City of Hutto

Planning and Zoning Commission

Tuesday, June 6, 2023 at 7:00 PM

RE: Lidell Walker Phase 1 Final Plat, Hutto, TX 78634
Final Plat Review – Lidell Walker Phase 1 Final Plat - Comment Report to Update #1 Submittal (received 5-8-23)
Project No.: 2057-PLAT

HEC-RAS Plan: Ult_v1 River: Mustang Creek Tr Reach: FLOWLINE Profile: PF 1

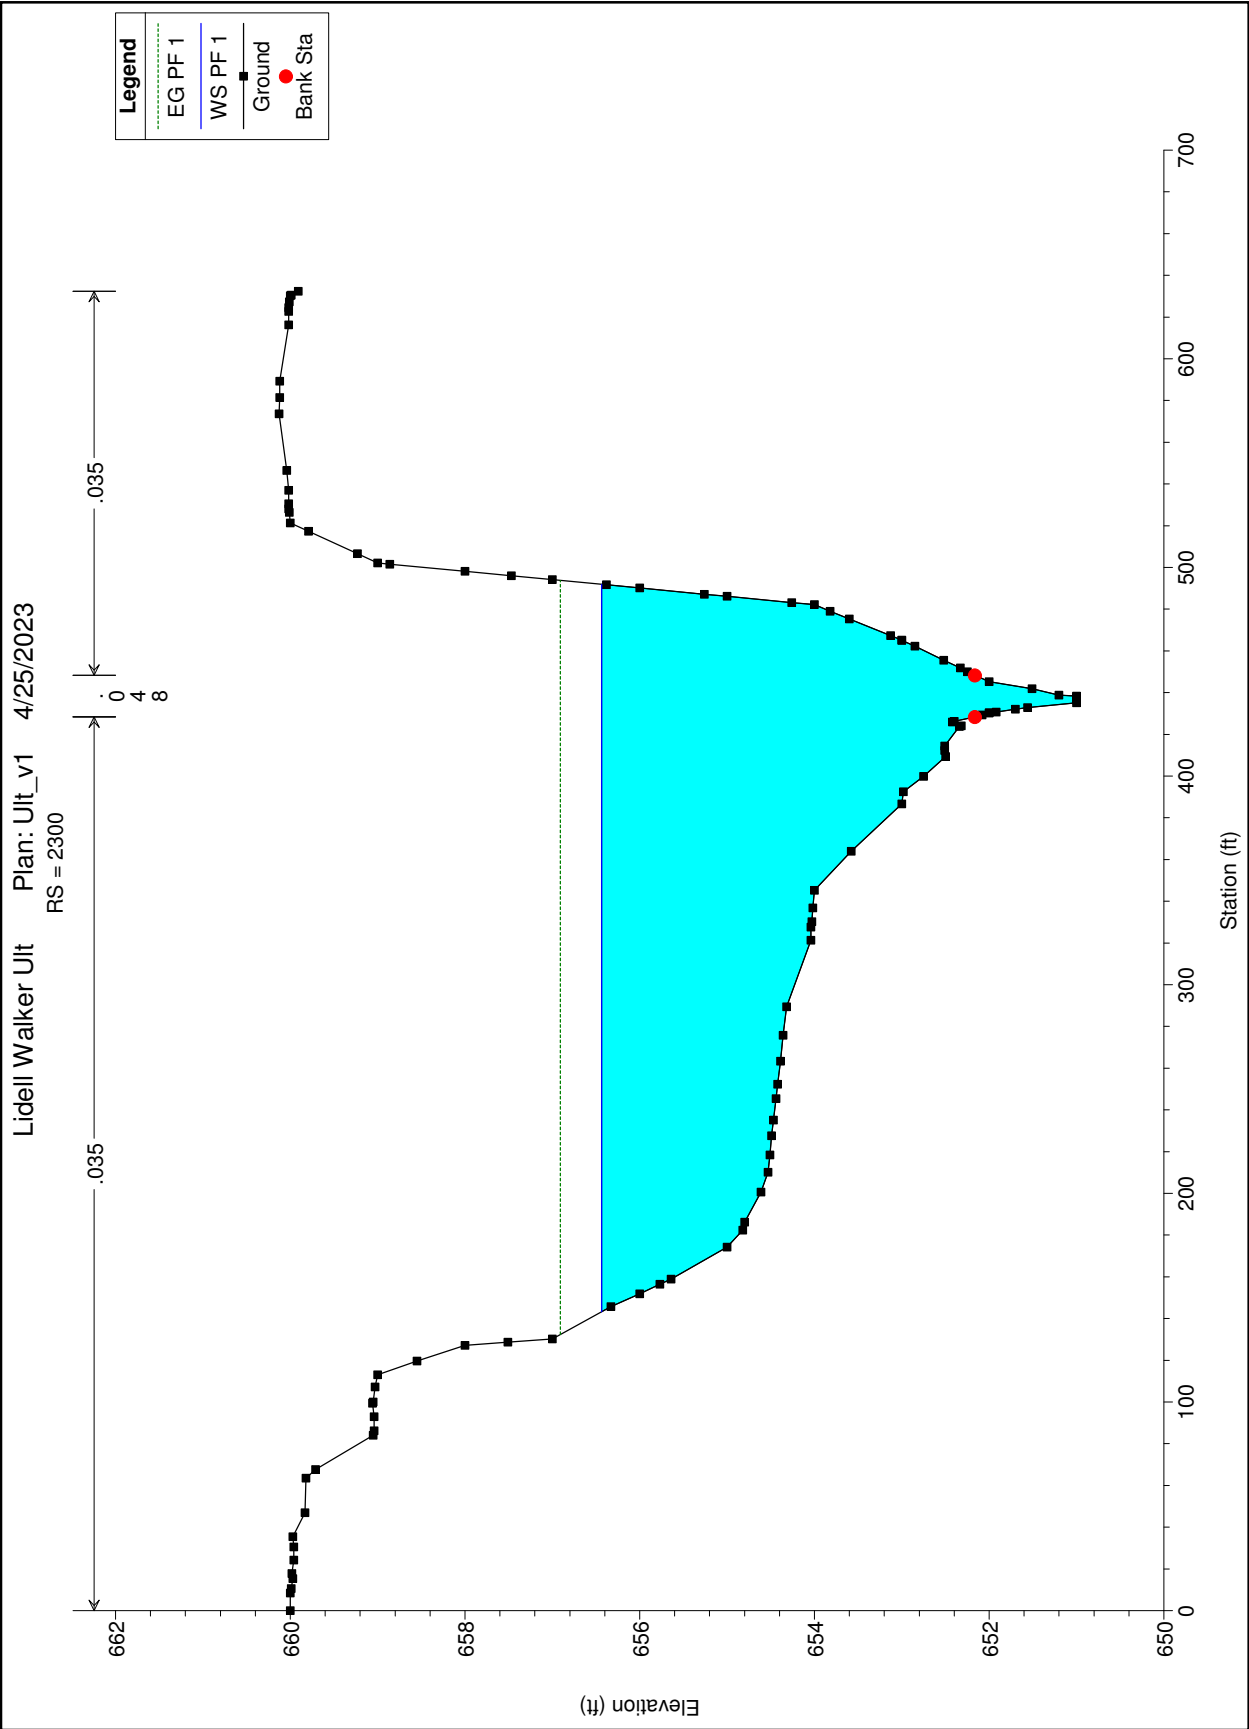
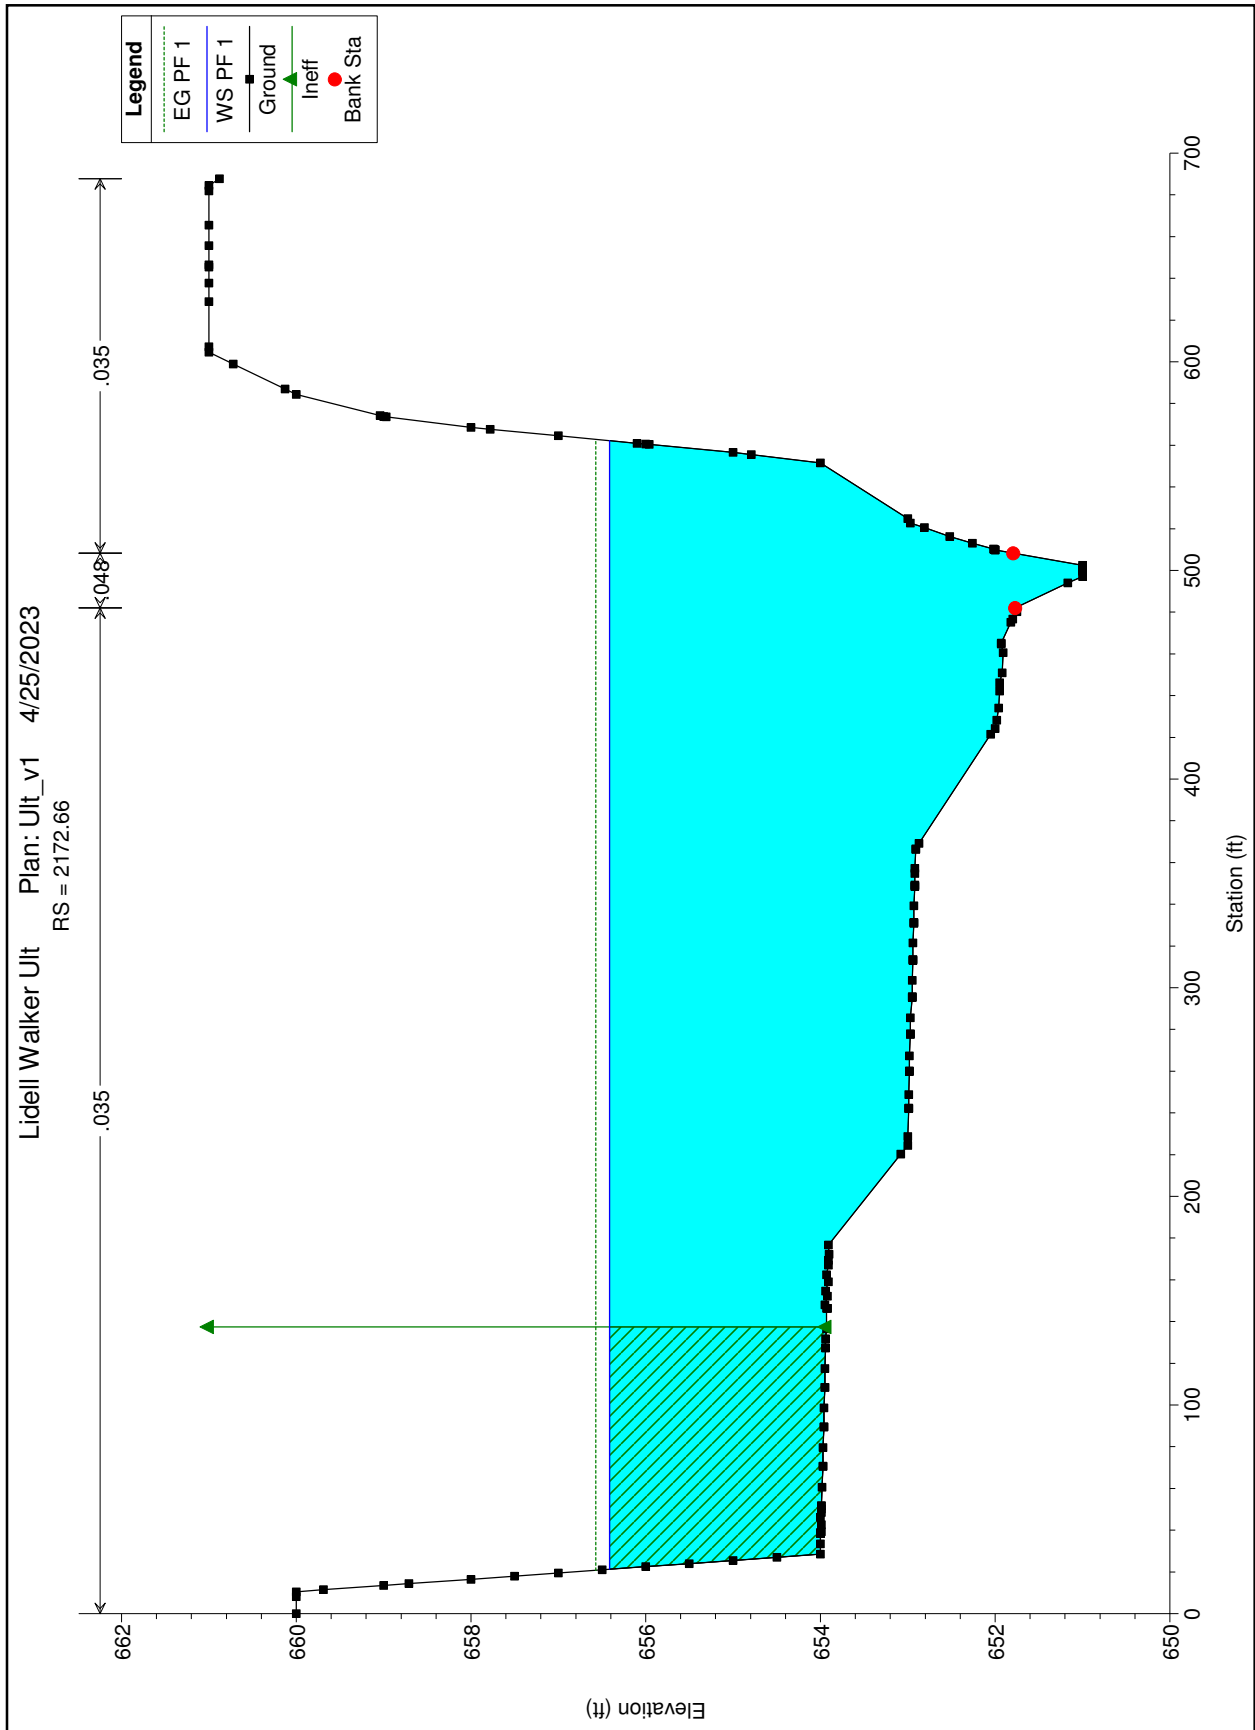
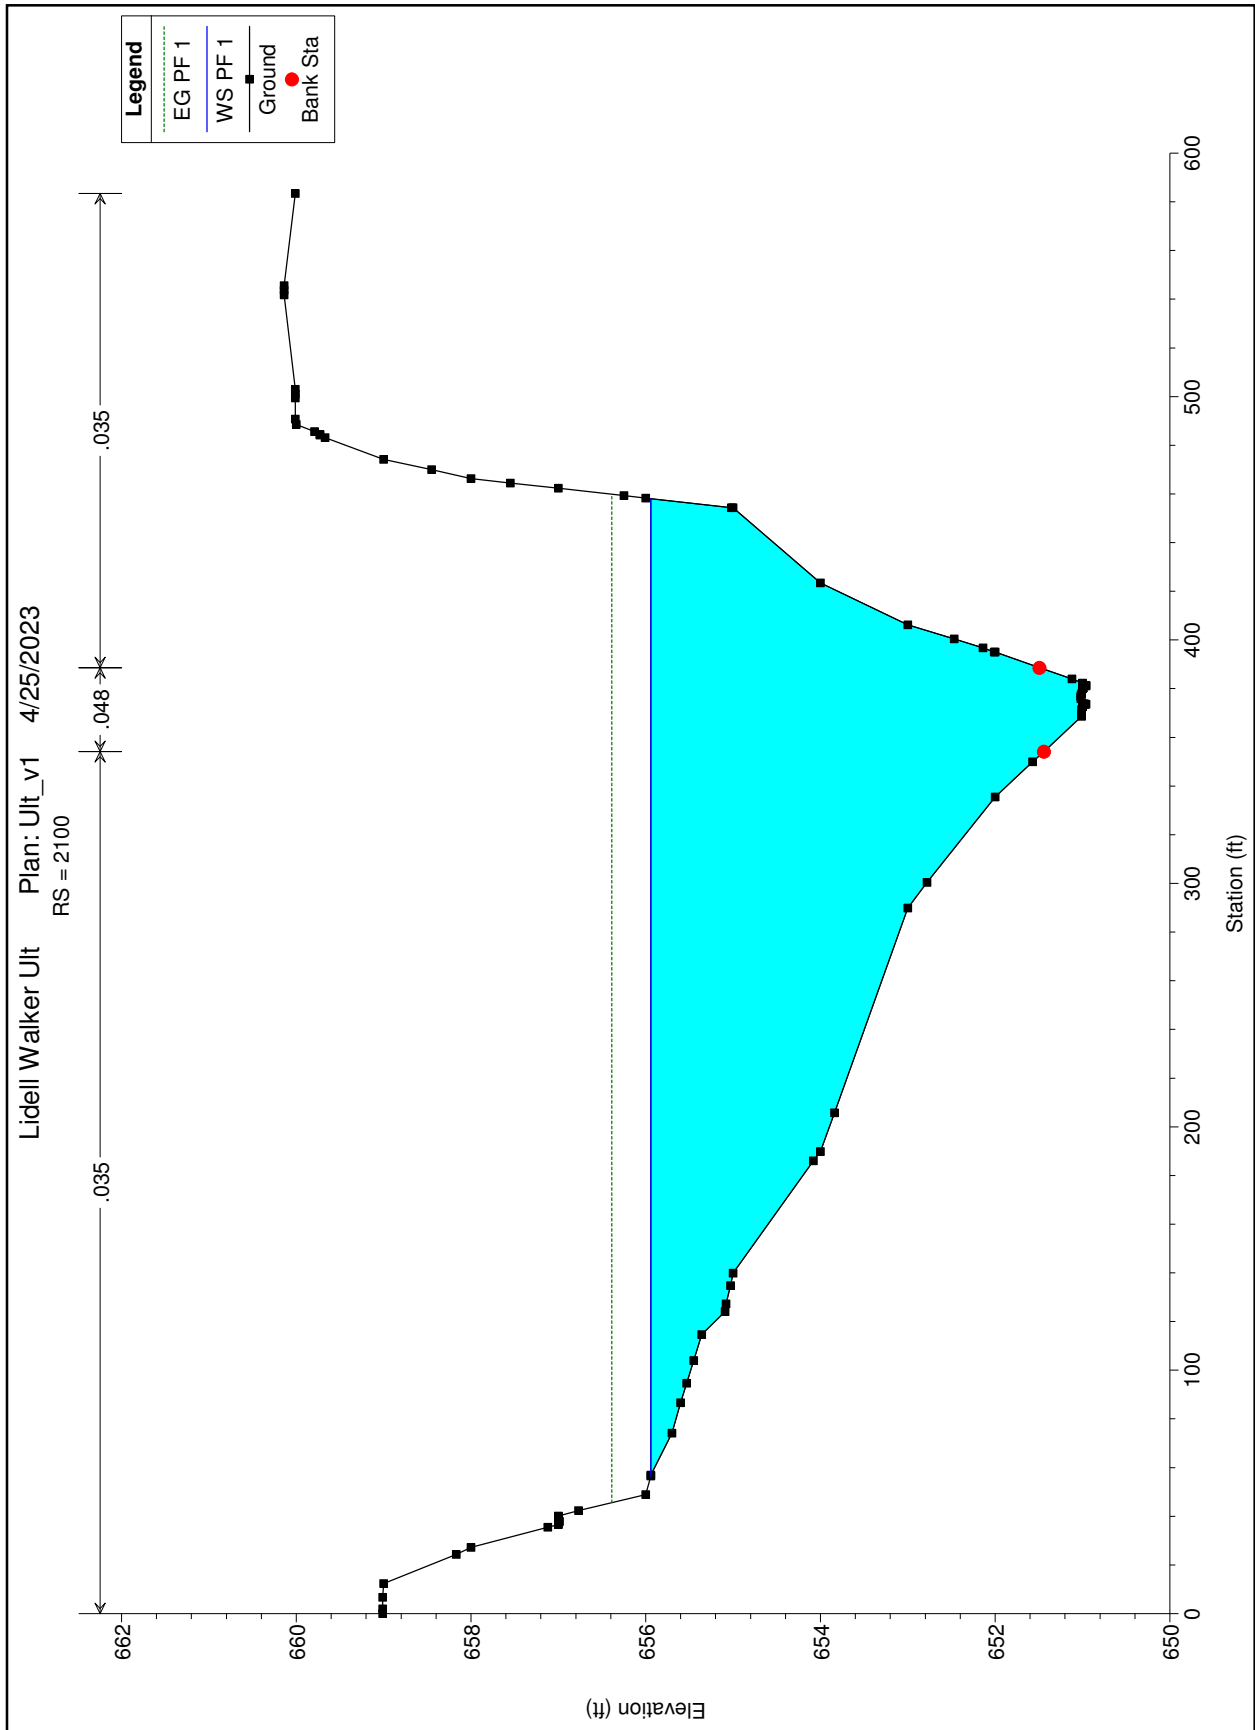
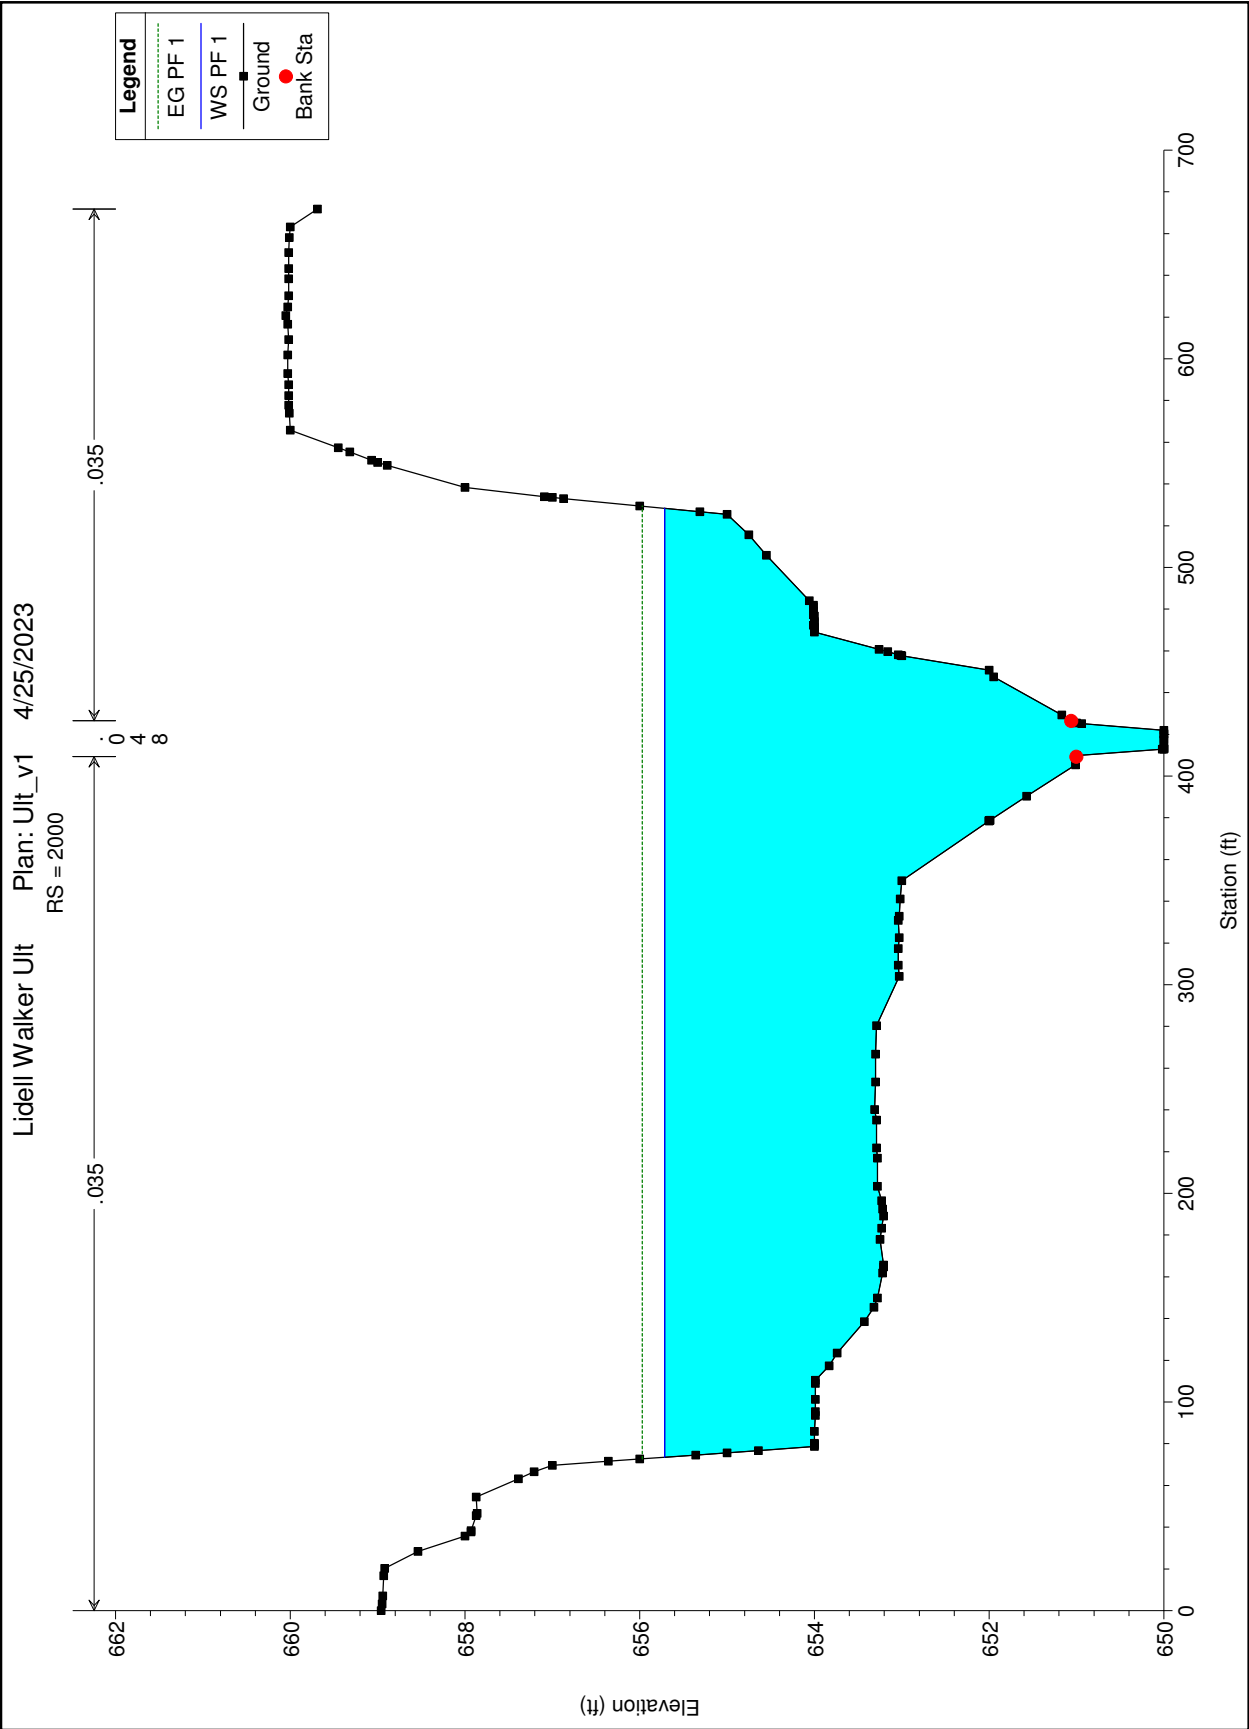
based on the drainage area maps there should be a flow change at station 200, 800, 1300, and 1800. according to the HMS analysis the final flow should be 4827.60.
